# MEMO

**To:** Kristopher Byrd, Well Construction Manager  
**From:** Tommy Laird, Well Construction Program Coordinator  
**Subject:** Review of Water Right Application G-19174  
**Date:** February 23, 2024

Application # G- 19174 re-review

**Stream-Depletion Model Results**

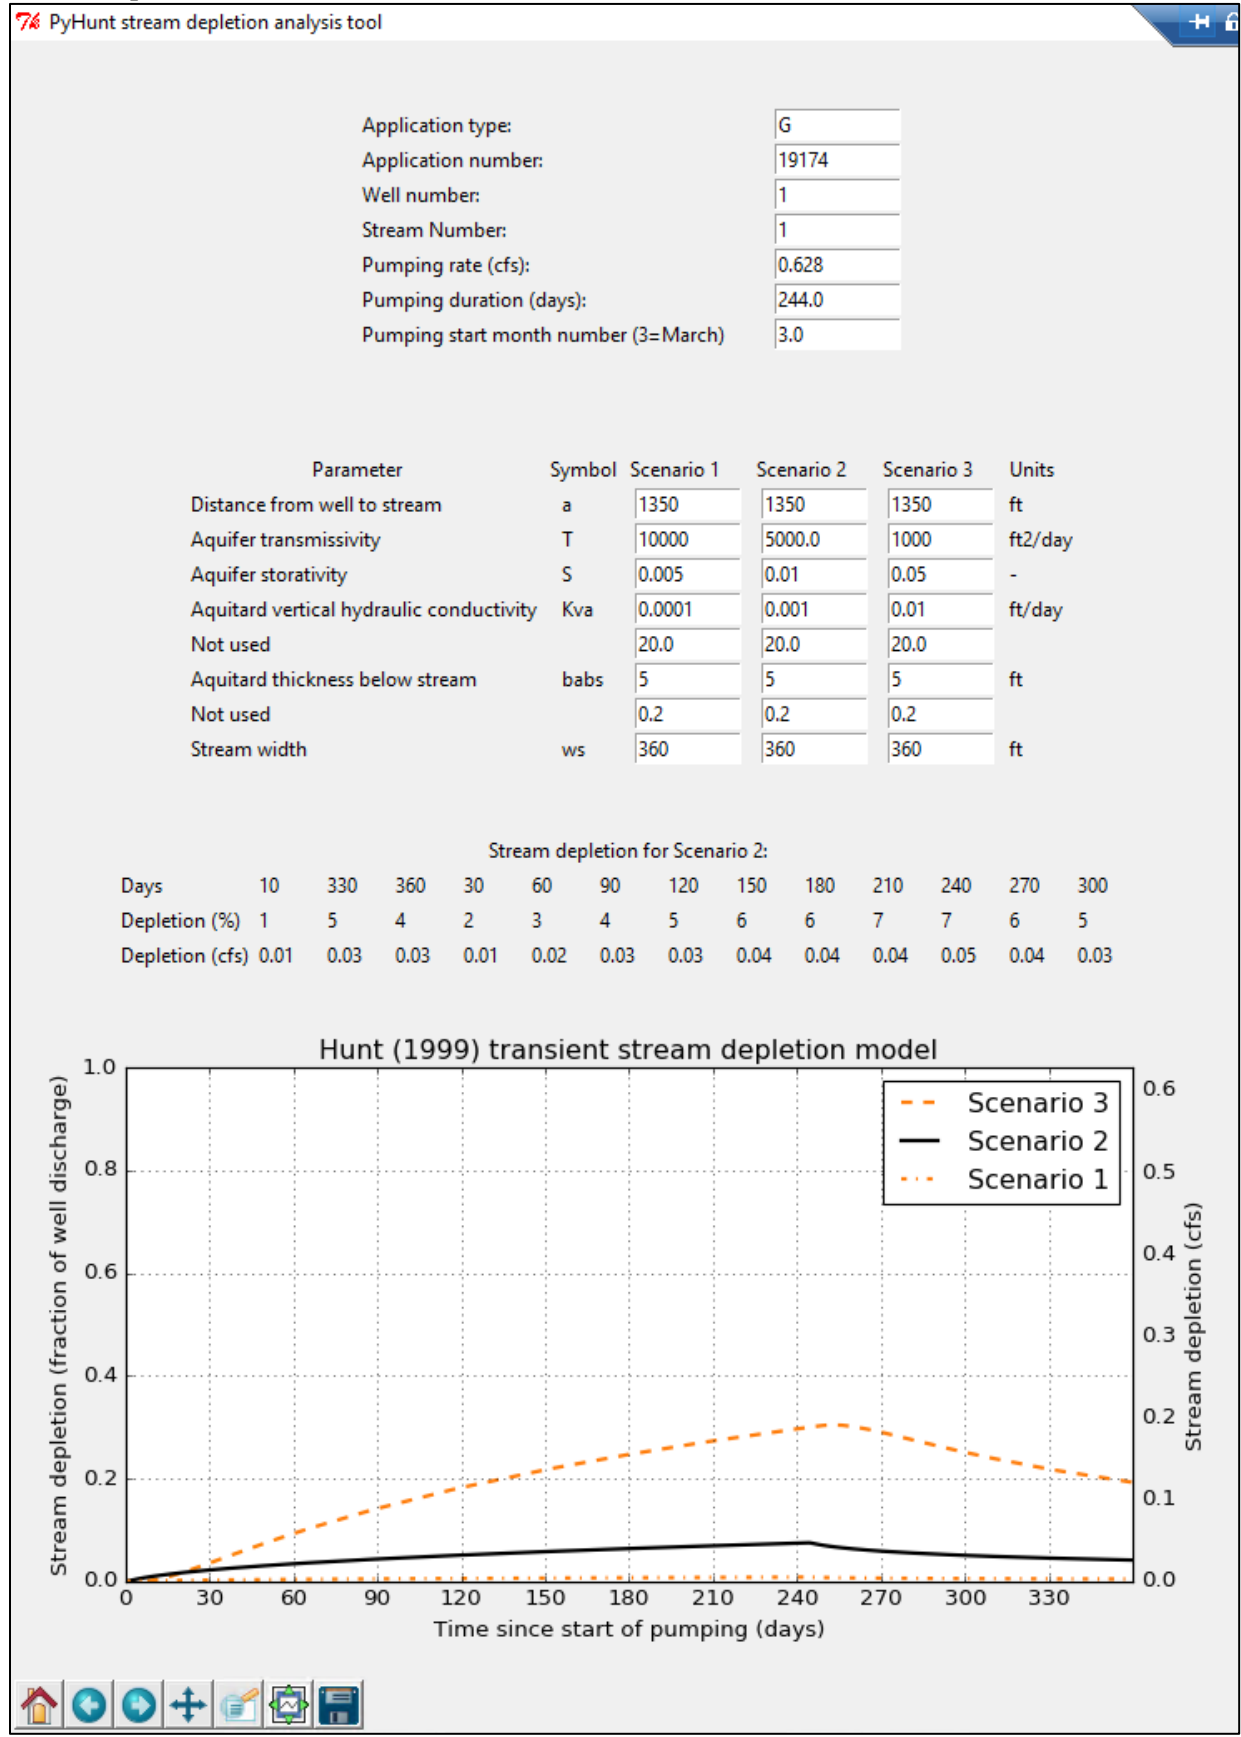
**Comments:** Stream-depletion was estimated using the Hunt-1999 stream-depletion model with parameter values set to a range of expected values given the geology

C6. **SW / GW Remarks and Conditions:** The proposed POA would be producing from an aquifer that has been found to be hydraulically-connected to surface water – specifically the McKenzie River – at a distance of less than 1 mile. The proposed rate of 0.628 cfs is less than 1% of both the instream right and the 80%-exceedance natural flows and the estimated stream-depletion is less than 25% @ 30 d so the proposed use is not assumed to have the potential for substantial interference.  
 \_\_\_\_\_  
 \_\_\_\_\_  
 \_\_\_\_\_
